**SUNDRY NOTICES AND REPORTS ON WELLS**  
*Do not use this form for proposals to drill or to re-enter an abandoned well. Use Form 3160-3 (APD) for such proposals.*

| 2. Name of Operator<br>DEVON ENERGY PRODUCTION CO LP    (6137)   |   | 8. Well Name and No.<br>CAPELLA 14 FEDERAL COM WELLS (listed below) |

DEVON ENERGY PRODUCTION CO LP RESPECTFULLY REQUESTS TO CHANGE THE BATTERY LOCATION AND FLOWLINE ROUTE ON THE FOLLOWING WELLS:

Devon Energy Production Co.  
Capella 14 Fed Com 1H  
330' FNL & 940' FEL  
Sec. 14-T19S-R31E  
Eddy County, NM

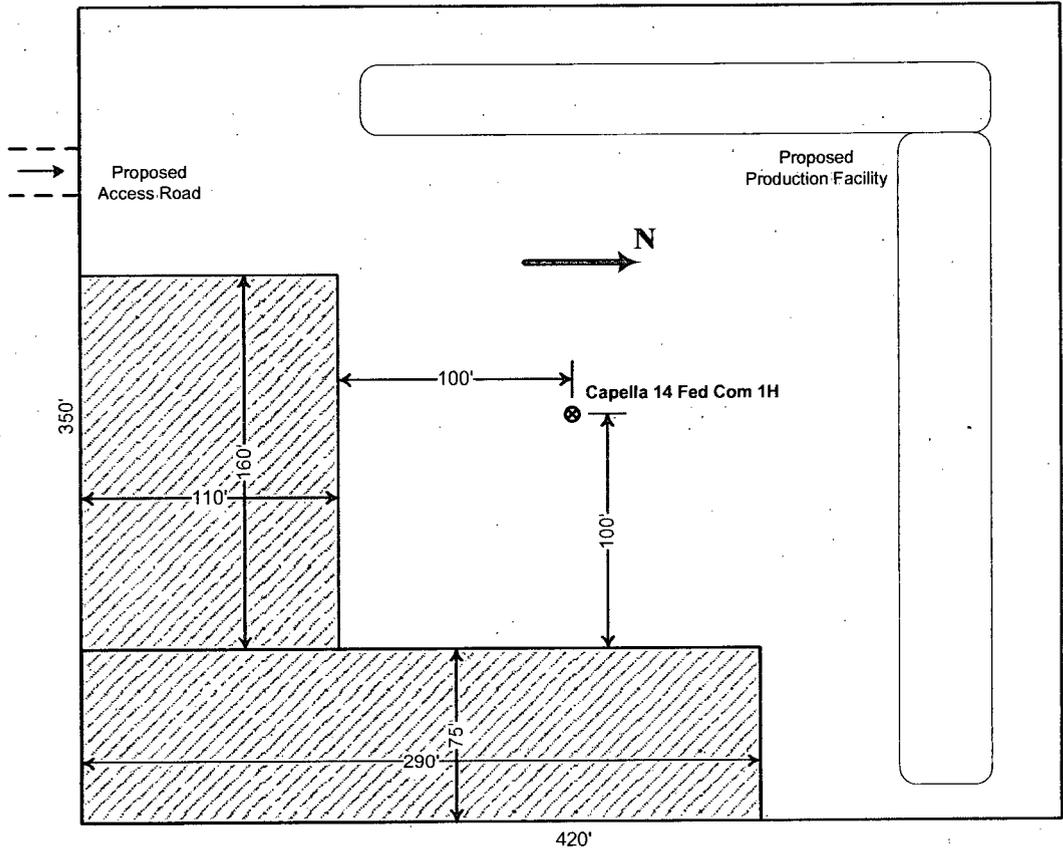
- 1H 30-015-39416 330' FNL & 940' FEL - THIS IS WHERE THE BATTERY IS BECAUSE IT WAS DRILLED FIRST (RIGLINE CHANGE)
- 2H 30-015-39413 330' FNL & 2490' FEL - FLOWLINE GOING TO #1 (DIAGRAM ATTACHED SHOWING ALL WELLS)
- 3H 30-015-39417 330' FNL & 1700' FWL - FLOWLINE GOING TO #1
- 4H 30-015-39418 330' FNL & 400' FWL - FLOWLINE GOING TO #1
